# UNITED STATES PATENT AND TRADEMARK OFFICE

| APPLICATION NO. | FILING DATE | FIRST NAMED INVENTOR | ATTORNEY DOCKET NO. | CONFIRMATION NO. |
|-----------------|-------------|----------------------|---------------------|------------------|
| 10/761,904      | 01/20/2004  | Chou Hsuan Tsai      | 2011152             | 4230             |

## Office Action Summary

**FIGURE A**

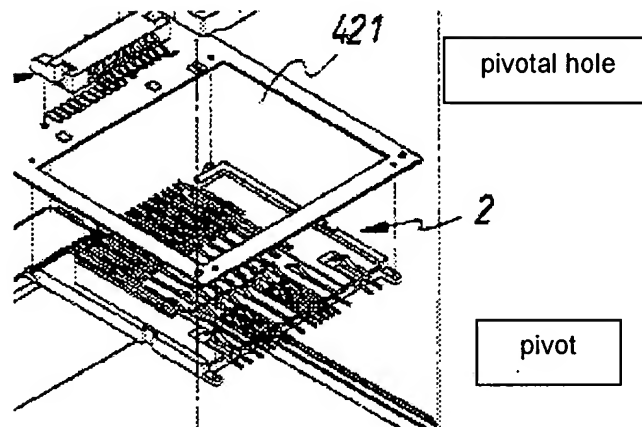
Regarding claim 2, the pins of the terminals protrude over a rear end of the at least one daughter base and the positioning structure comprising pivots (see a FIGURE A below) formed at two sides of the at least one daughter base and pivotal holes (see the FIGURE A below) formed on the mother base at positions corresponding to the pivots such that the rear end of the at least one daughter base may be moved vertically relative to the mother base.
